California High Speed Rail Authority

TASK ORDER NO. PG&E 003

CHSRP Interaction Removal or Relocation Plan

BO072-1

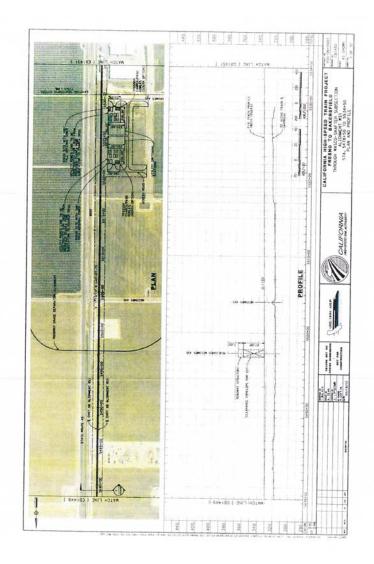
Enclosed and by reference this letter refers to Drawing CB 1450 and 1451, 3 and 4 of 32 sheets, WASCO-SHAFTER subsection Alignment WS1 Stations 5478+50 to 5562+50. The drawing is of Plan and profile. According to the drawing referred the alignment interferes with an existing almond processing plant called "Sunnygem Almonds". The interference is that the plant exists on a series of rectangular parcels in the city limits of Wasco and the tracks as proposed would take out necessary space in the rear so that it severs the plant to make it useless. The plant cost and value is in the neighborhood of 50 million dollars. While there may be some utility in what remains the severance is severe and would destroy or displace a viable almond processing business causing the loss of potentially 500 jobs in addition to the cost of the plant.

The undersigned is available to meet and discuss the matter. Our suggestion is to realign. I understand that the rail is a massive undertaking and location and alignment will create affects to the businesses located on lands in its path. The affect here is not lower cost farm land but the destruction of a factory operation that will be quite expensive for the tax payers. It would be cheaper to relocate the road adjacent than to encroach onto the factory property in this manner.
